SUBJECT: Forwards FSAR page changes for fuel pool cooling system.
 Changes will be incorporated into amend within four months.

Subject: SUPPLY SYSTEM NUCLEAR PROJECT NO. 2
FUEL POOL COOLING SYSTEM MODIFICATION

Enclosed are sixty (60) copies of the WNP-2 FSAR page changes for the Fuel Pool Cooling System Modification. These changes will be incorporated into an amendment within four months.

FUEL POOL COOLING AND CLEANUP SYSTEM

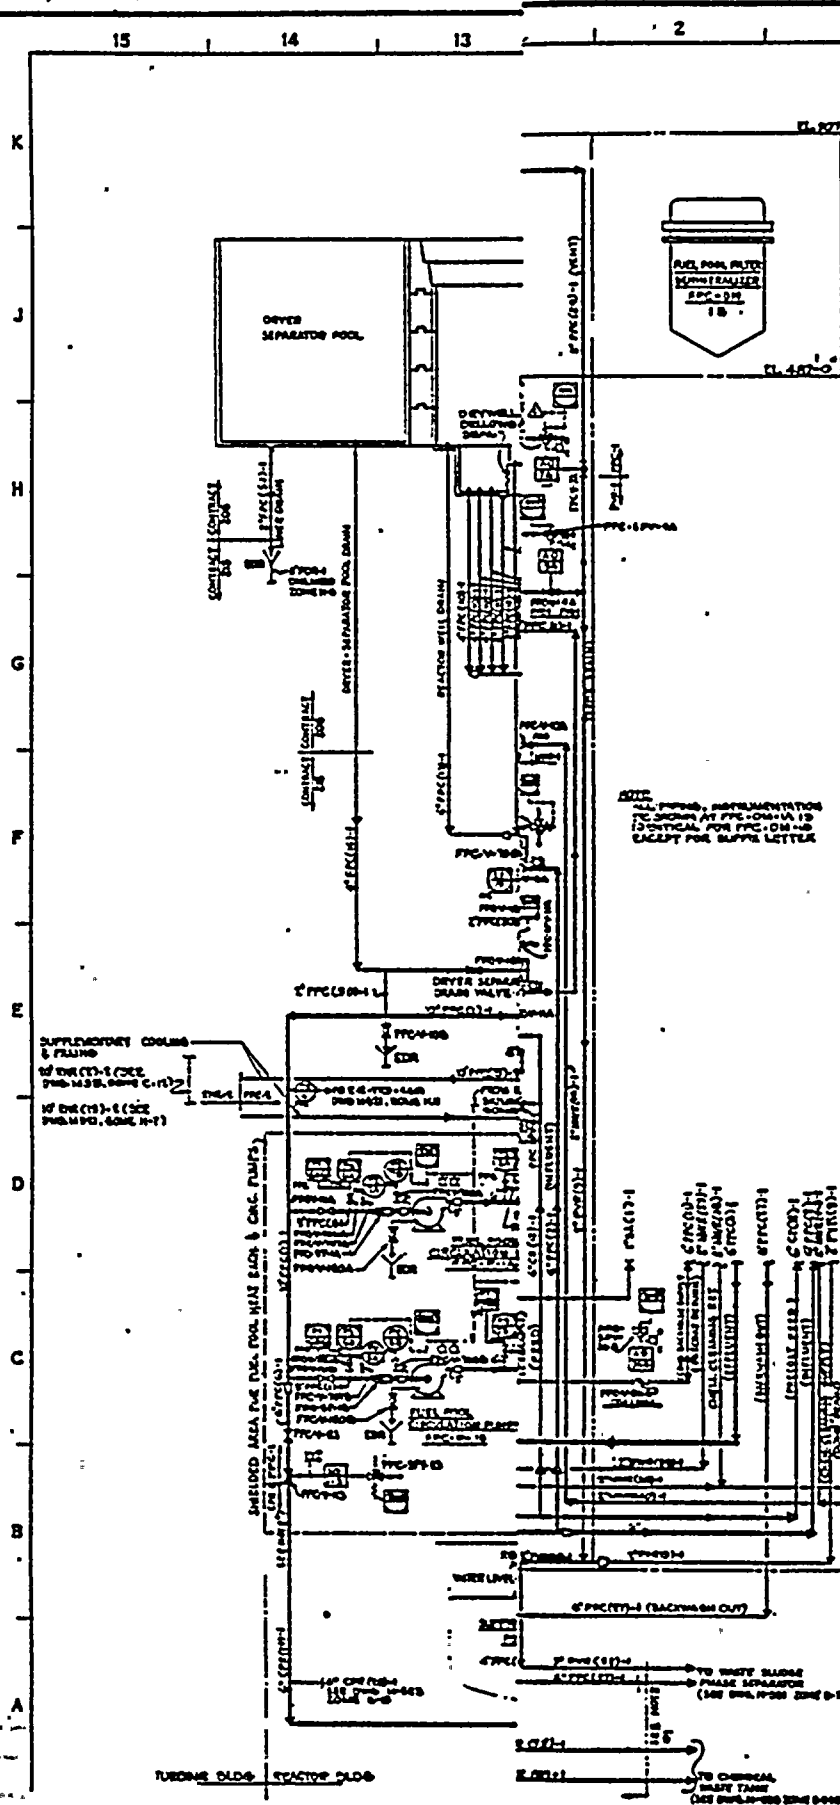
Revise to show upgraded FPC System.

**FIGURE
3.2-13**

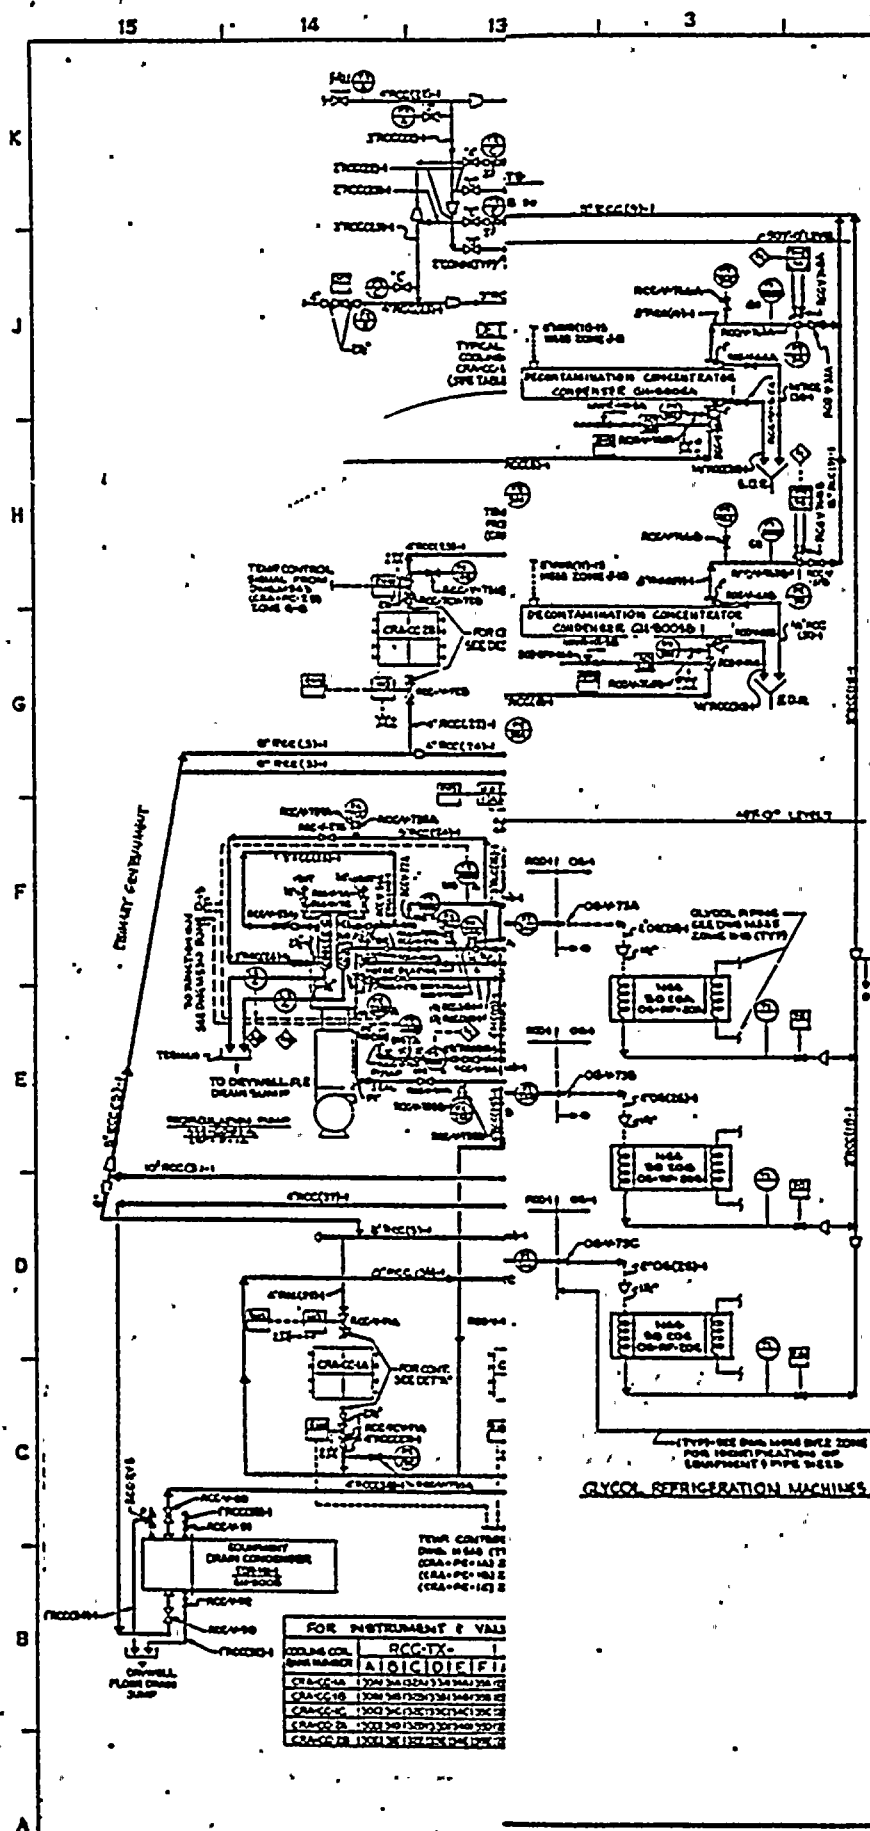
Revise to show S.W. tie-in to RCC.

CLOSED COOLING WATER SYSTEM
REACTOR AND RADWASTE BUILDING

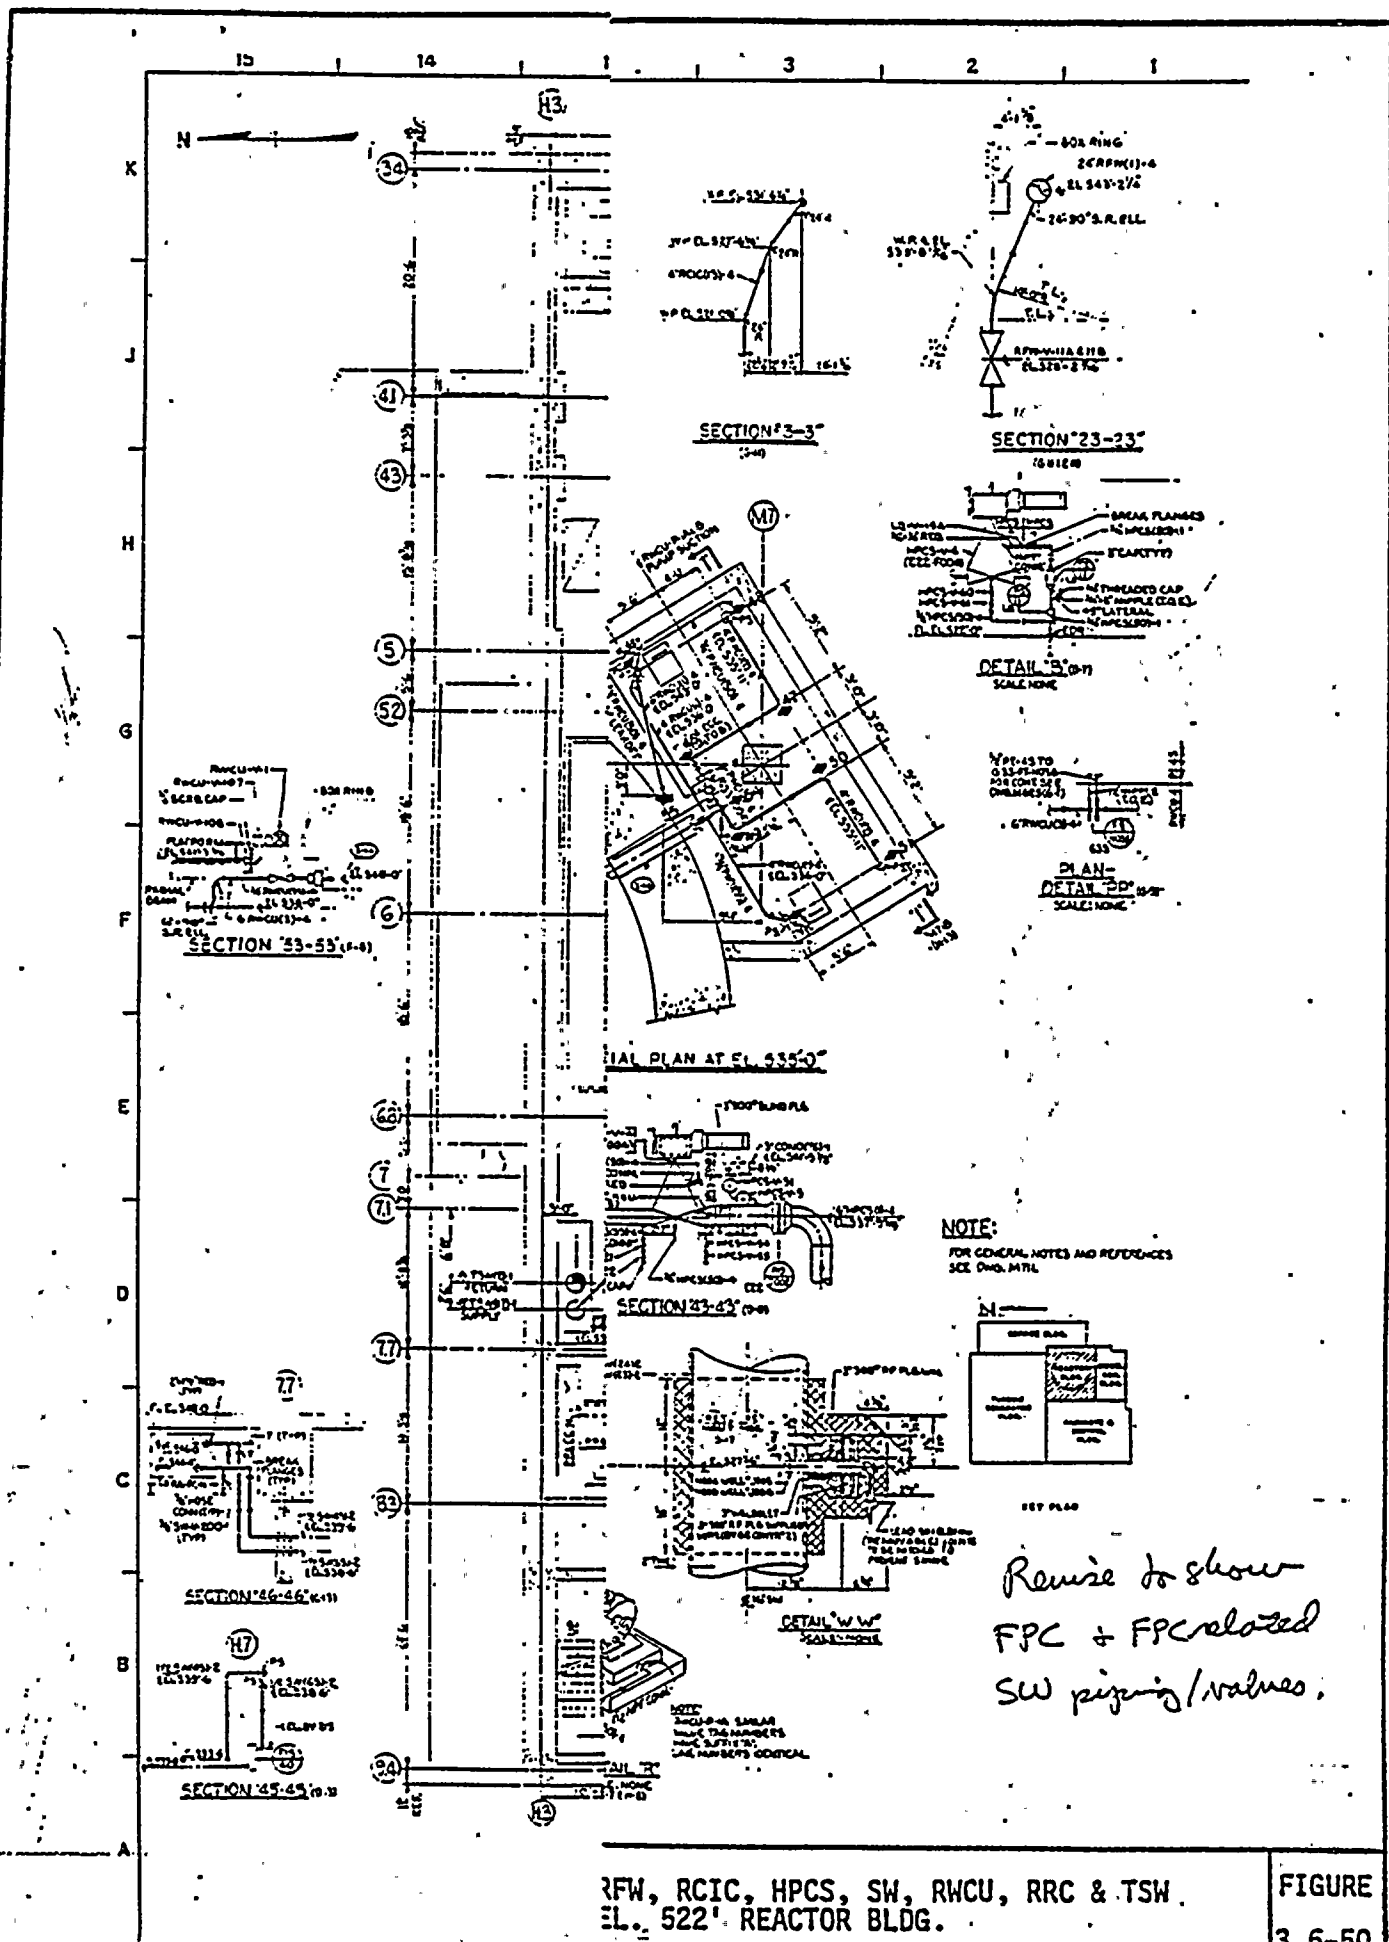
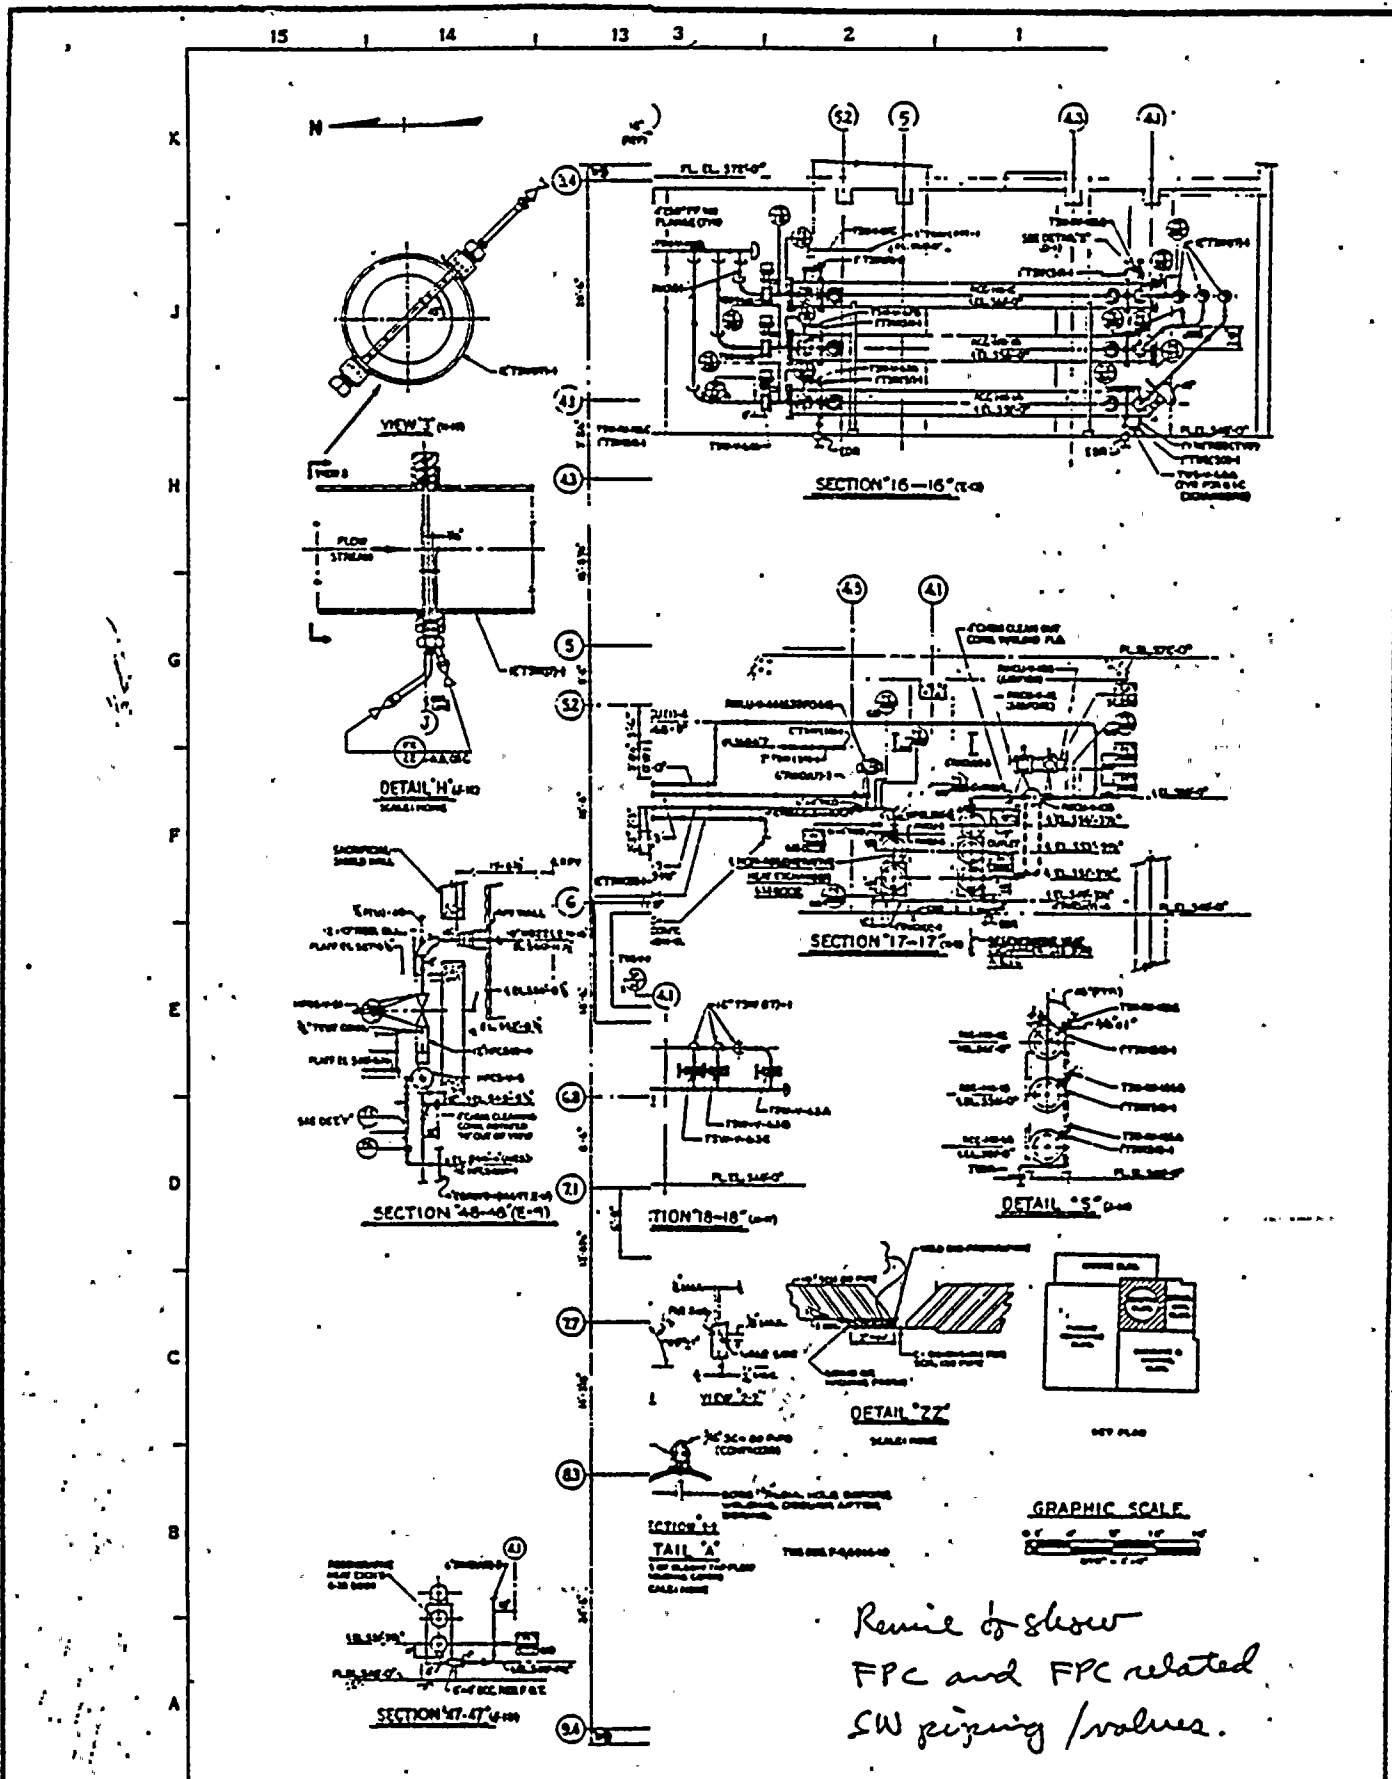
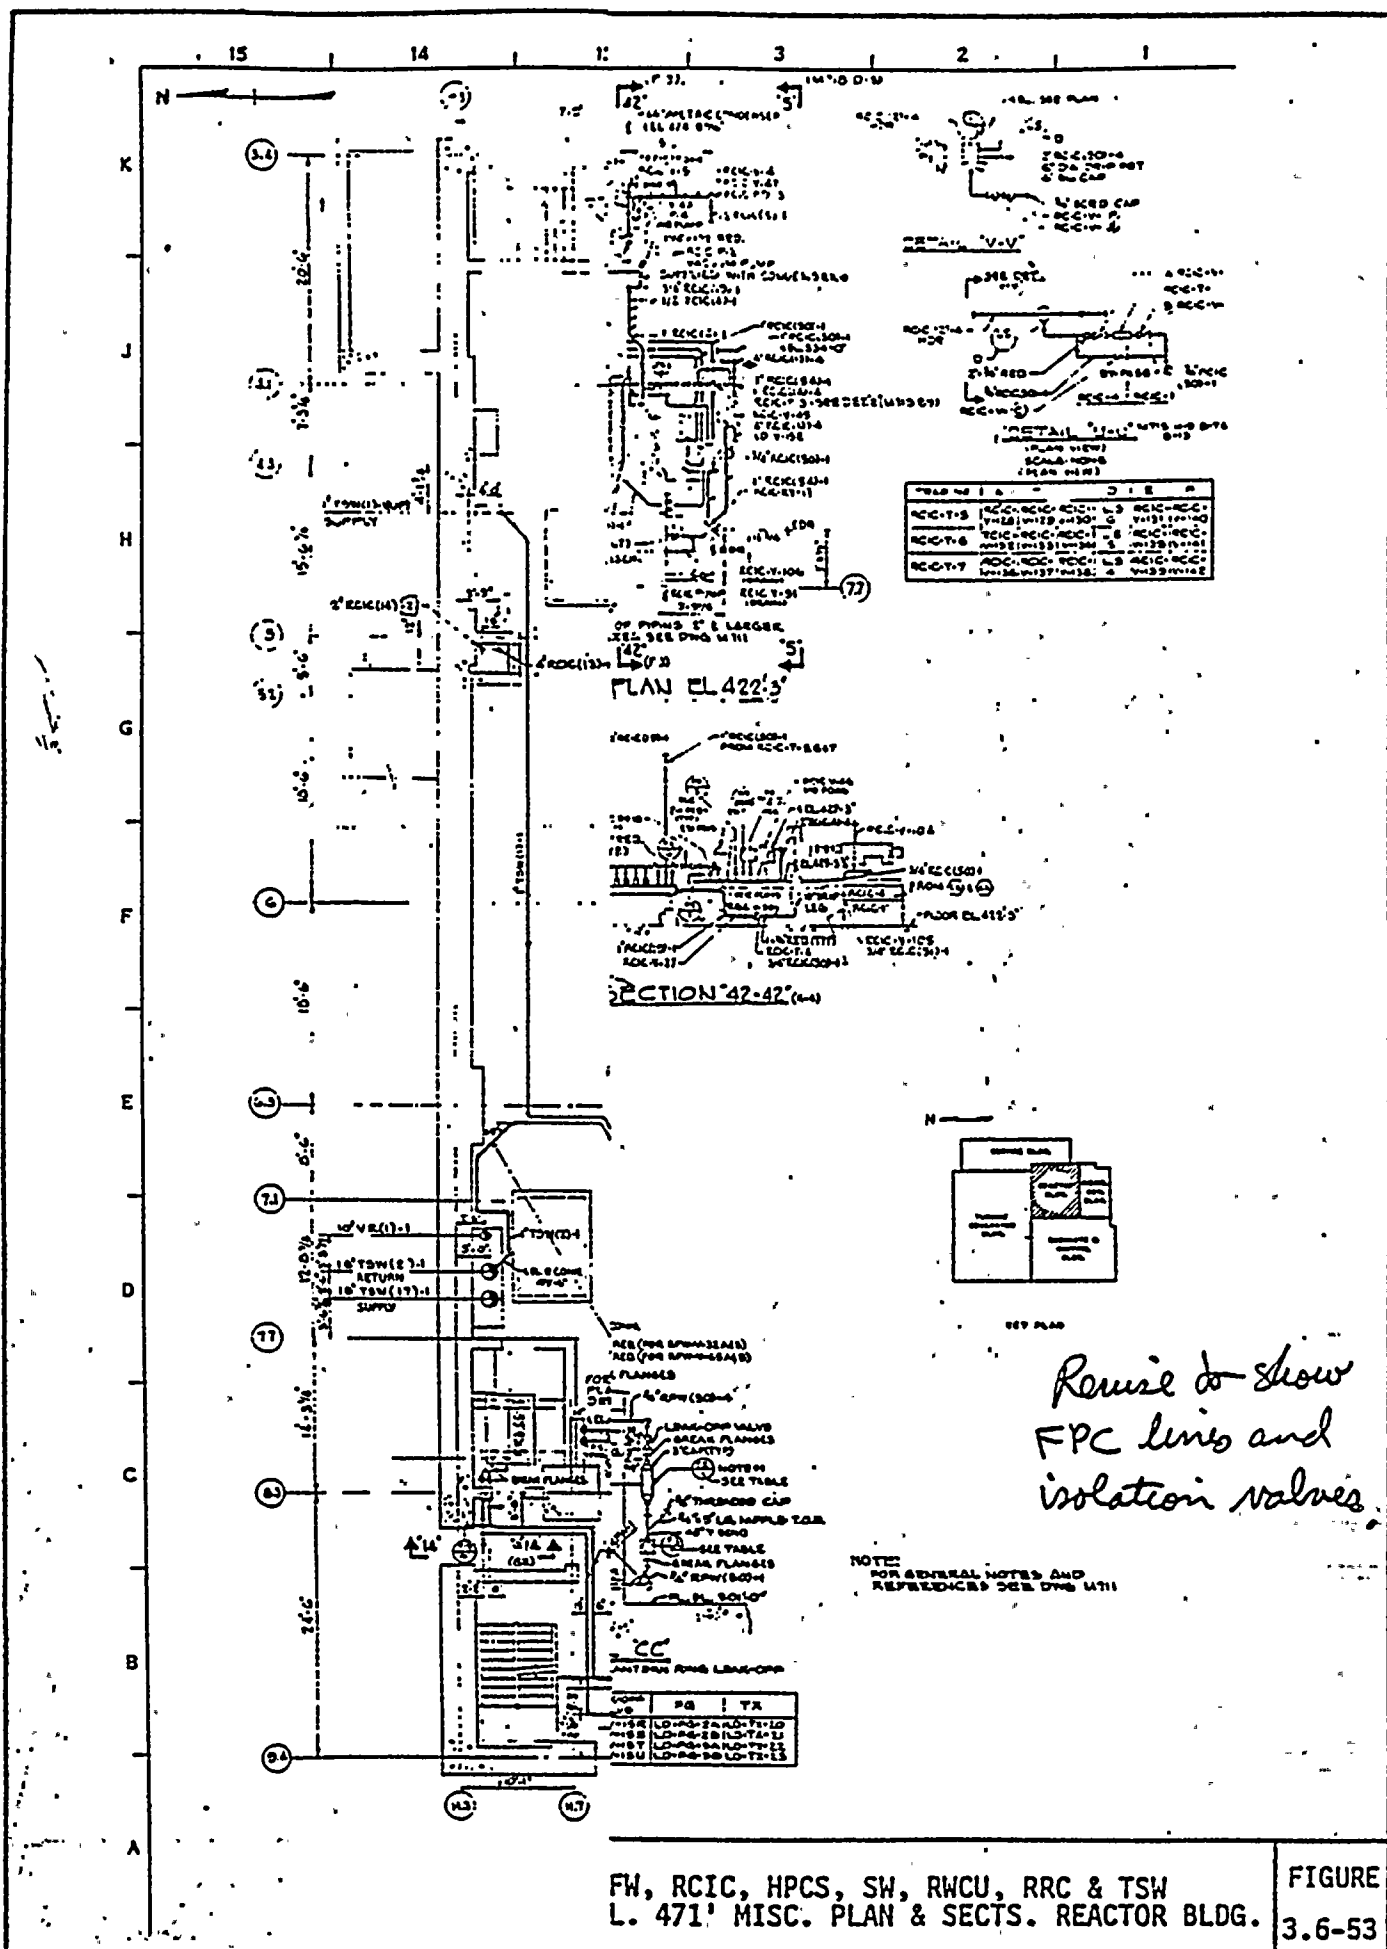
Revise to show FPC room coolers as Safety Class 3.
